RUSSELL VALE COLLIERY UEP

Response to the PAC Second Merits Review

for
Wollongong Coal Ltd
December 2015

**RESPONSE TO THE PAC SECOND
MERITS REVIEW**

**Figure 1
Corrimal Fault & Dyke D8 (SCT, 2015)**

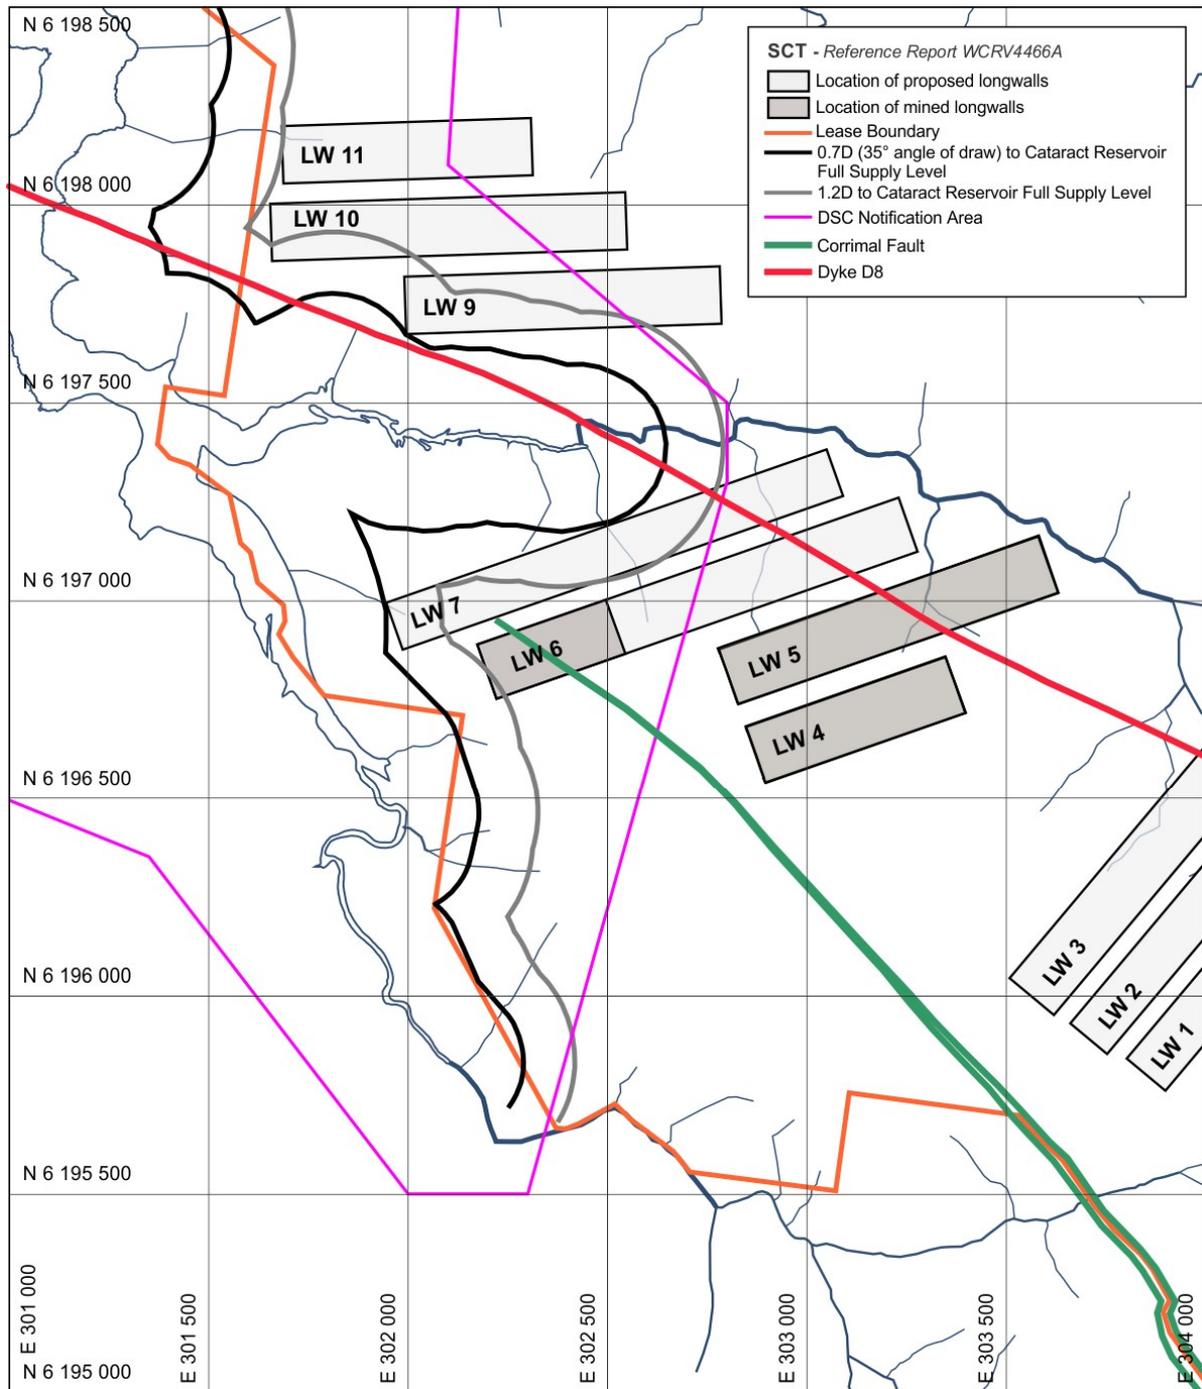
Various presenters purported specific errors in the groundwater model predictions and assumptions (e.g. that shear plane not included in model, bores GW1 and RV20 were not in a relevant position, height of drainage zone not determined).

The Risk Assessment included a comprehensive investigation into the geometry and characteristics of the Corrimal Fault (SCT, 2015). The Corrimal Fault has been intersected numerous times by workings in the Bulli and Balgownie seams. Observations made during these intersections have enabled SCT to predict the dimensions and alignment of the Corrimal Fault. A three-dimensional representation of the Corrimal Fault is shown in **Figure 1**.

Based on the most recent intersection of the Corrimal Fault during mining of LW 6, the Corrimal Fault is expected to taper out in the vicinity of LW 7. Therefore, the fault does not provide connectivity to Cataract Reservoir. Furthermore, the lack of elevated mine inflows during previous intersections of the fault indicates that the Corrimal Fault is not water bearing.

Figure 1: Plan showing Water NSW Drawing D2013 overlain with the proposed mine plan, full supply level of Cataract Reservoir as determined to contemporary mine survey standards, and the 35° angle of draw protection barrier calculated using the industry standard approach (Holla et al 1993).

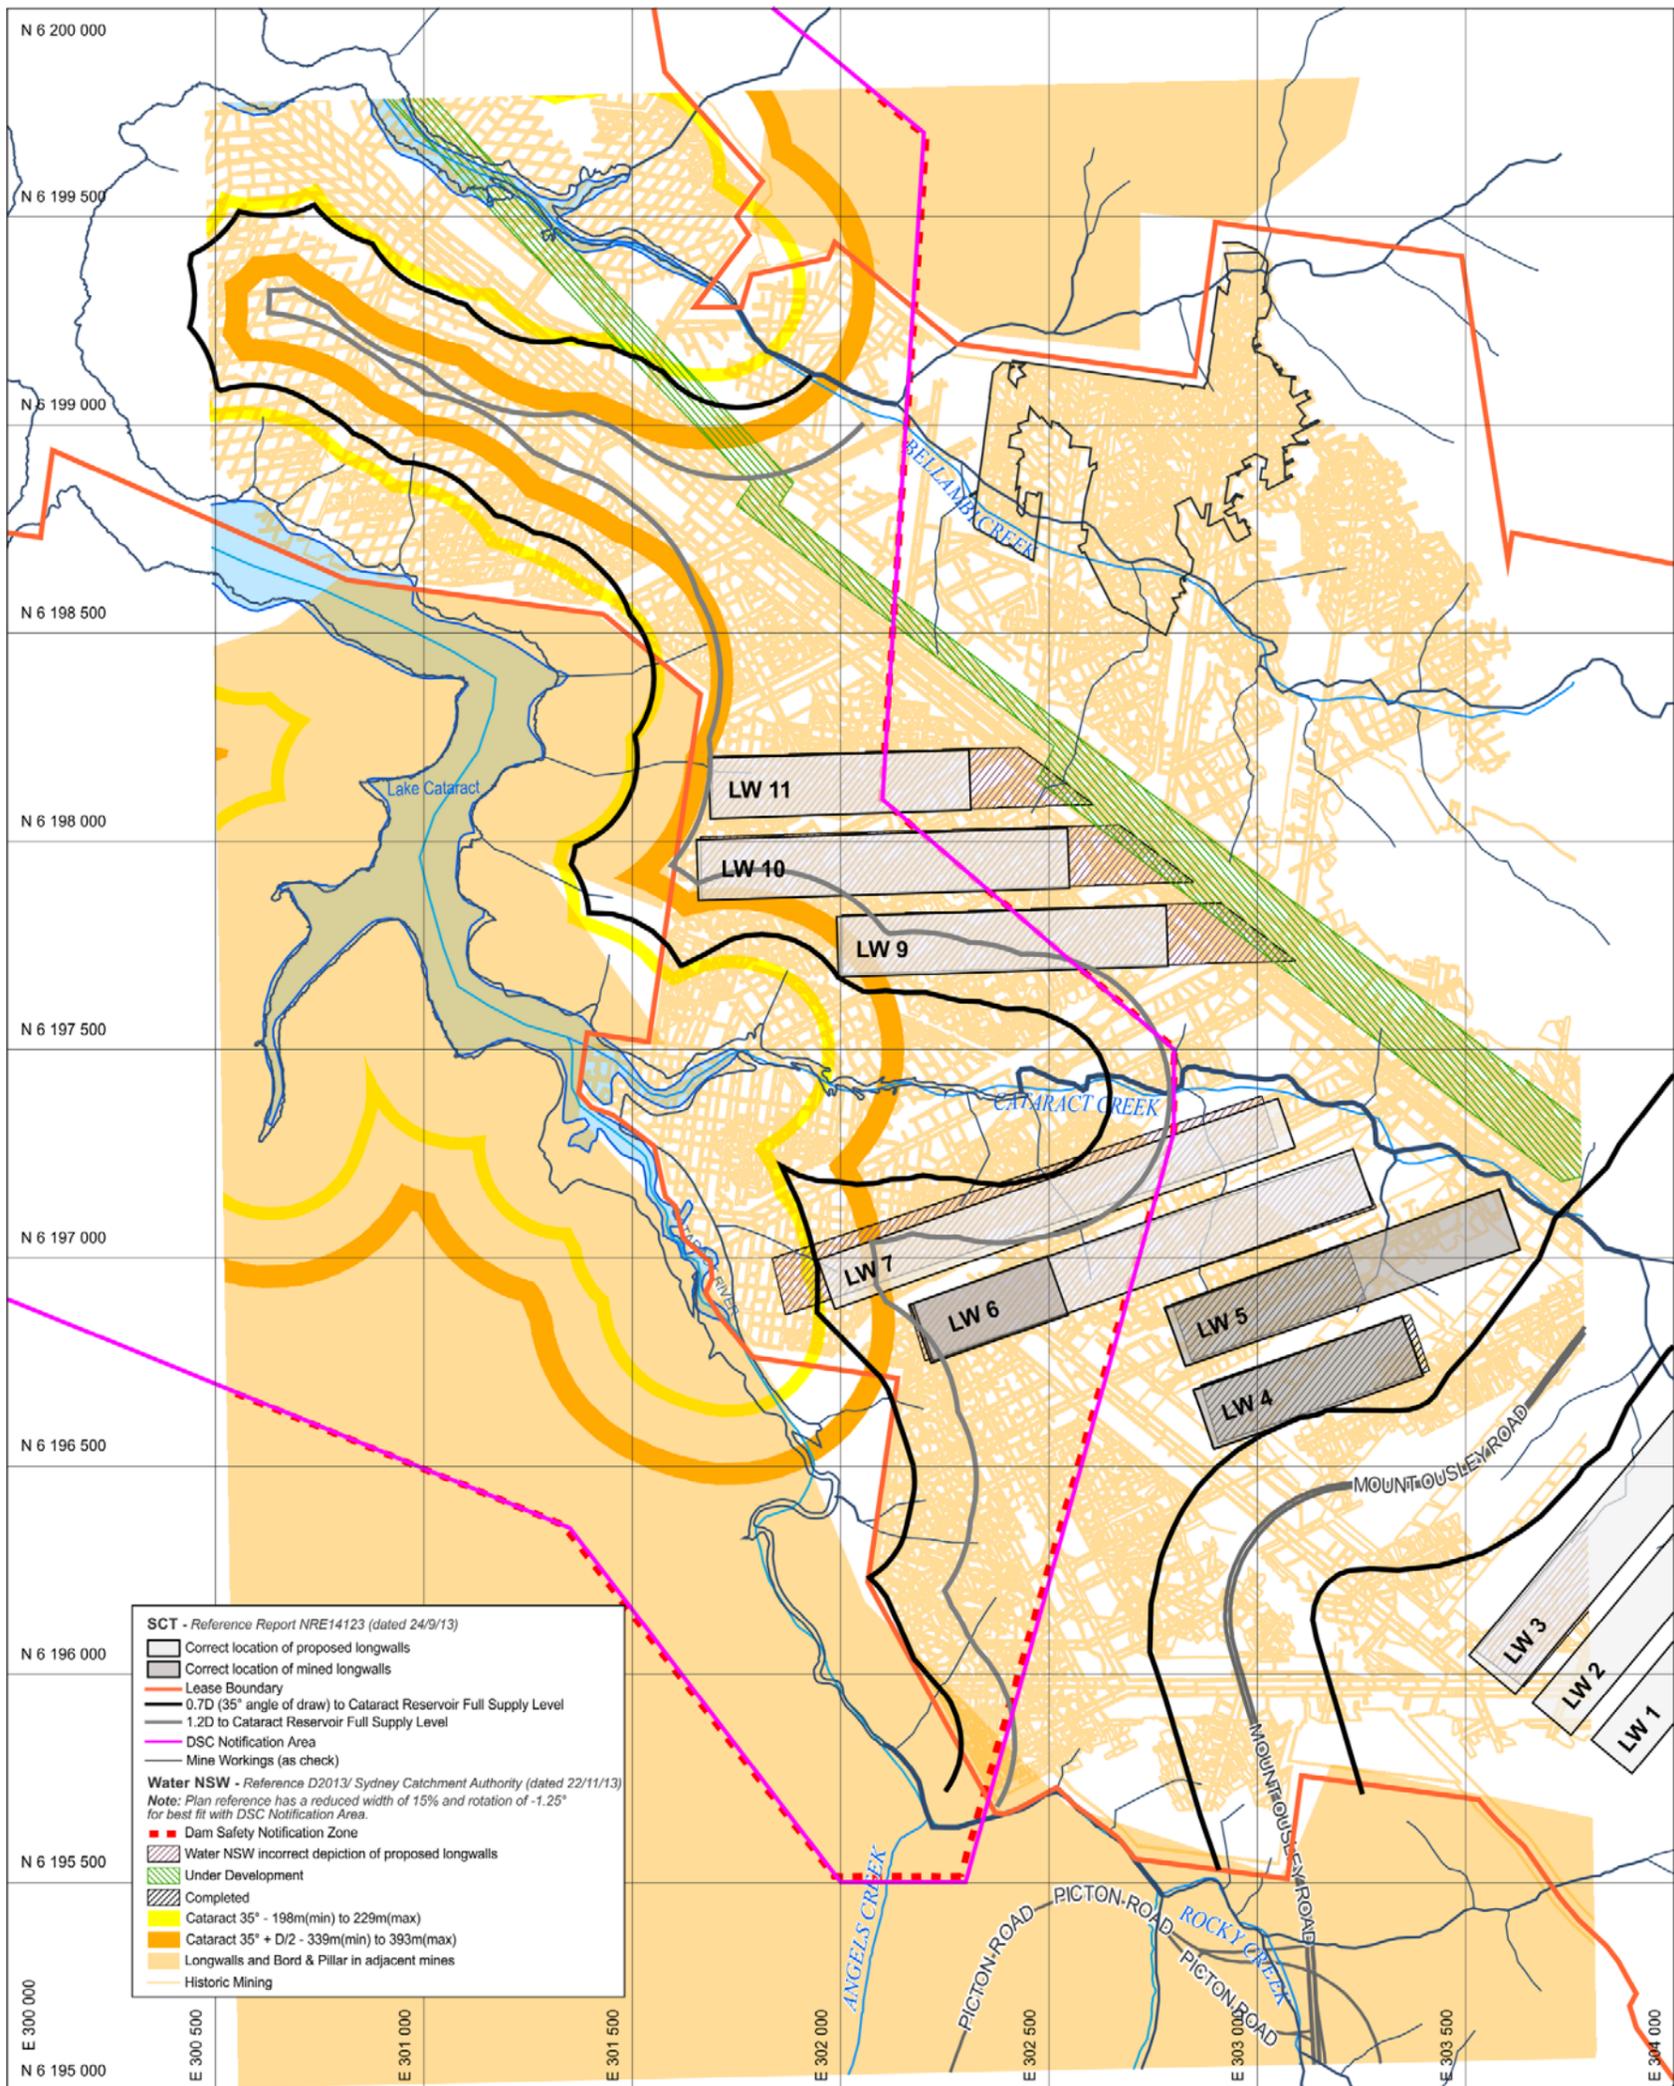
WaterNSW queried the angle of draw used in SCT's assessments.

Figure 1 shows the proposed UEP-PPR mine plan, full supply level (FSL), and mine workings, overlain on top of the drawing Trim Ref: D2013 created for the then SCA by John Bickmore and dated 22 November 2013 (referred to here as Drawing D2013).

It is noted that the version of Drawing D2013 attached to the Jessie Evans email was significantly distorted. The drawing had to be reduced in width by 15% relative to its height and rotated by -1.25° in order to provide a reasonable match with the actual plan of the proposed mining in MGA coordinates. The misalignment of the edge of the Drawing D2013 with the MGA grid provides an indication of the extent of the adjustment that was required. The plans used as the basis for figures in SCT reports were prepared for the UEP-PPR by the registered mine surveyors for Wollongong Coal. These plans form the basis of the figures presented in SCT Report NRE14123 dated 24 September 2013 (and a subsequent update WCRV4263 dated 18 June 2014). The correlation between the actual DSC notification area in MGA coordinates and the notification area as depicted in Drawing D2013 provides an indication of the accuracy of the final match that was able to be achieved.

Drawing D2013 misrepresents the proposed geometry, particularly in respect to the length, width, and position of Longwall 7, but also the length and extent of most of the other panels as well. It appears that the geometry of Longwall 7 was not updated in Drawing D2013 from the original UEP. Other panels were updated to partially reflect the revised UEP-PPR geometry but not Longwall 7. For the UEP-PPR, Longwall 7 was reduced in length and width and offset to the south so as to remain outside the 35° angle of draw barrier protecting Cataract Reservoir, including the portion of the reservoir that extends up Cataract Creek.

The full supply level (FSL) for Cataract Reservoir is inaccurately presented in Drawing D2013. The FSL presented in the drawing appears to be based on a 1:25,000 topographic series map. The FSL presented in SCT reports is based on plans produced during the 1960's and 1970's by the then Metropolitan Water Sewerage and Drainage Board (MWS&DB) from aerial photographs that together with local mine site ground surveys have become the customary basis for locating the FSL for depiction on statutory mine plans and record tracings of colliery workings in the Southern Coalfield.

On the basis of the work that has been done, the FSL as presented in SCT reports is considered to be accurate enough for practical purposes and consistent with legislated survey standards.

Figure 2: Industry standard approach for calculating protection barriers (Holla et al 1993).

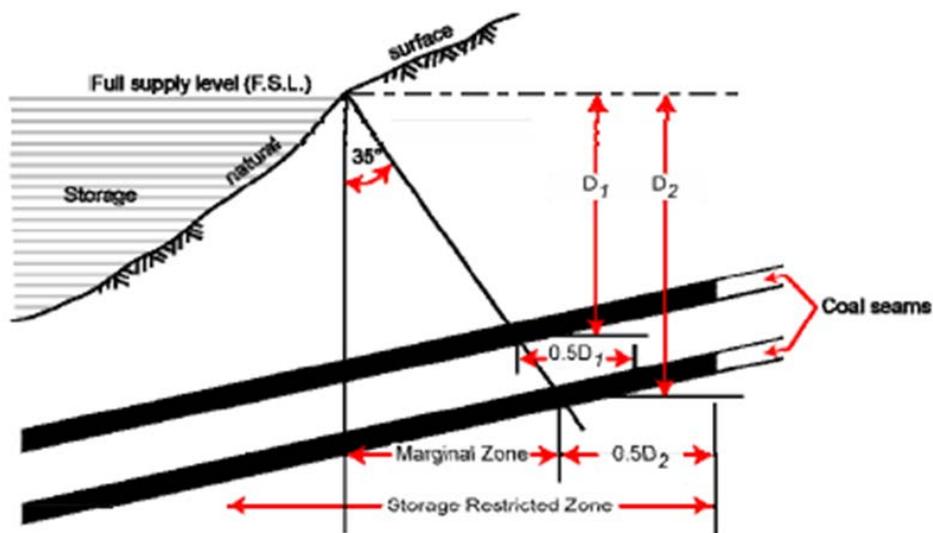
The Water NSW calculations presented in the spreadsheet attached to the Jessie Evans email use a mix of overburden depths that are not representative of the depth of mining at the FSL. When the correct depths are used, the calculated barrier sizes are consistent with those presented in the SCT reports and used as the basis to offset panels from Cataract Reservoir.

The 35° angle of draw protection barrier provided to the FSL of Cataract Reservoir has been calculated using the approach presented by Holla et al (1993) and reproduced in the spreadsheet attached to the Jessie Evans email (reproduced here in Figure 2). This approach is industry standard for protecting features such as Cataract Reservoir.

The overburden depth to the Wongawilli Seam used for calculating the protection barrier is based on a three dimensional model of seam elevation developed from surveyed data from the Bulli Seam mine workings and measured separation between the Bulli Seam and the Wongawilli Seam. This model is considered to be sufficiently accurate for practical purposes.

It is noted that the 35° angle of draw protection barrier presented in the SCT reports is consistently more conservative than the equivalent barrier presented in Drawing D2013. This conservatism is particularly evident in the vicinity of Longwalls 7 and 9, both of which are constrained in length in the UEP-PPR plan by the protection barrier. Longwall 7 has also been narrowed and offset so as to remain outside the barrier. Both panels would be much less constrained using the barrier presented in Drawing D2013
